11V-509  
(7 pages)

## **PART 573 Defect and Noncompliance Report**

15 ¾" Equalizer for 10K/12K Spring Axles manufactured by Rockwell American

DRAWN: JVN	Model: ax4113-10H equalizer
DATE: 10/14/2011	Desc: Center equalizer for axle hanger
Prod. Line: ax	
GVWR: /bs	DIMENSIONS IN FEET / INCHES (UNLESS OTHER-WISE NOTED)
SHEET: 1 OF 1	10 and 12k equalizer weld failure

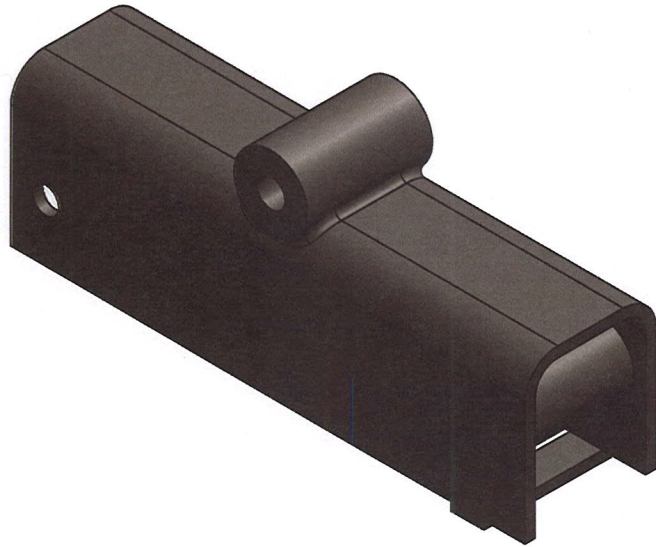
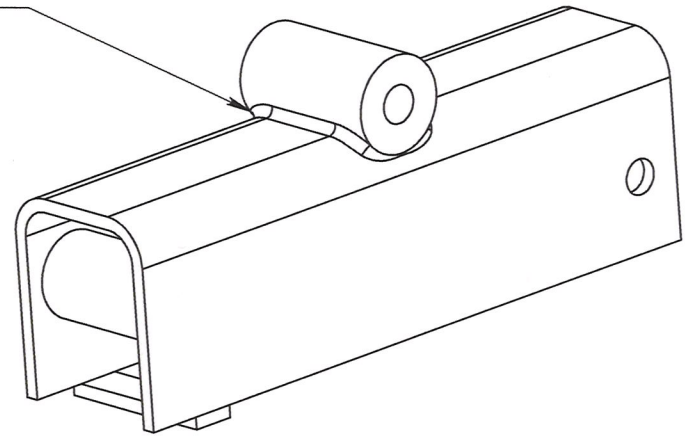
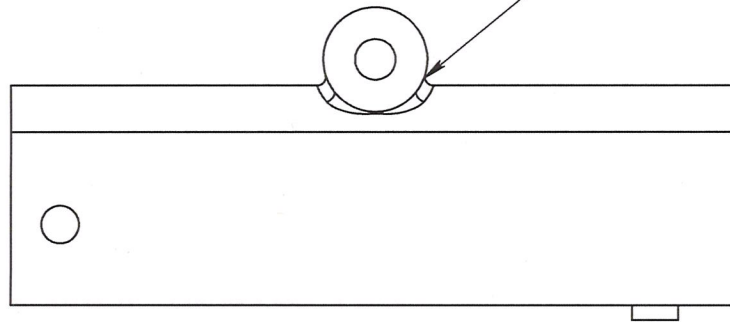
The design of the equalizer is more than sufficient when properly welded. However, the failure of this piece of equipment appears to result from welds that do not penetrate into the metal. The welds of concern occur on the top of the equalizer and hold the bushing where the equalizer bolts to the trailer. It is believed that the problem equalizers were built at the beginning of a lot, before the welding equipment was set properly.

The failure of this weld can result with little to no warning, depending on the amount of penetration that is present. This failure will cause the equalizer to separate from the trailer, and in extreme circumstances, could cause one or more axles to detach from the trailer. A separate illustration is provided, showing the area of concern on the equalizer.

Weld failure area

This is the area of concern

On all current stock, additional welding is being done to increase the size of the weld as well as wrap it around the bottom of the tube  $\frac{3}{4}$ " on each side. Every trailer that goes out after 10/17/11 will have the increased weld size.

Through proper settings, parameters and quality testing during the manufacturing process, the welding can be controlled and appropriate. As a part of this process, on all future manufacturing, the weld size will be increased 67% and the overall length of the weld will be increased  $\sim\frac{3}{4}$ " on each side of the tube and wrapped over the radius of the part. This will increase the factor of safety by 3.5 times.
